INCH-POUND
MIL-H-83511/1
AMENDMENT 1
15 October 1999

HEADSET, ELECTRICAL
H-251A/U

This amendment forms part of Military Specification Sheet MIL-H-83511/1, dated 04 April 1978, and is approved by all Departments and Agencies of the Department of Defense.

Alternate locking thumbnut configuration.

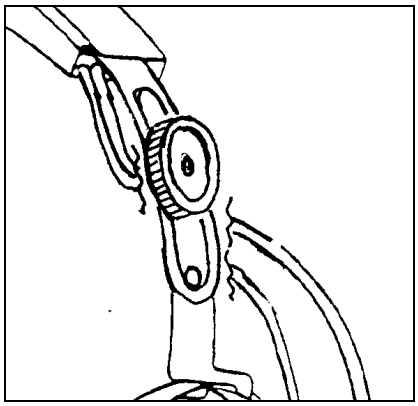
FIGURE 1: Add to Figure 1 Alternate configuration to the sliding action is a positive locking thumbnut.
